Product Change Notice

Issue Date: 09-May-2022

Smart Display PCB Solder Mask Change for Leopard, Cheetah and Saxon 4D 0.15

Below is the appearance comparison of HCMS-290x for reference:

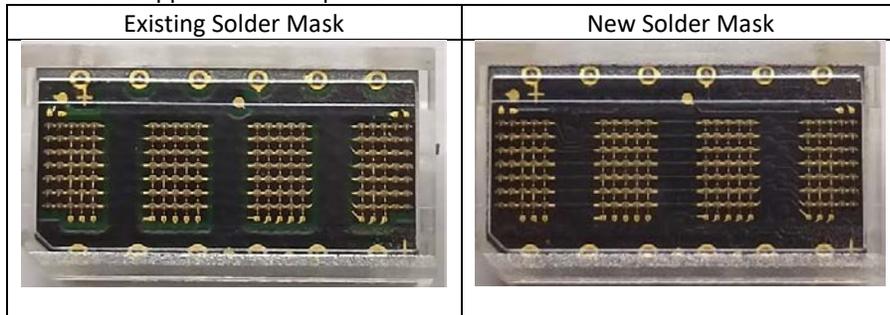
Solder mask optimization and material change. The new solder mask fully covers the PCB, providing a better cosmetic appearance.
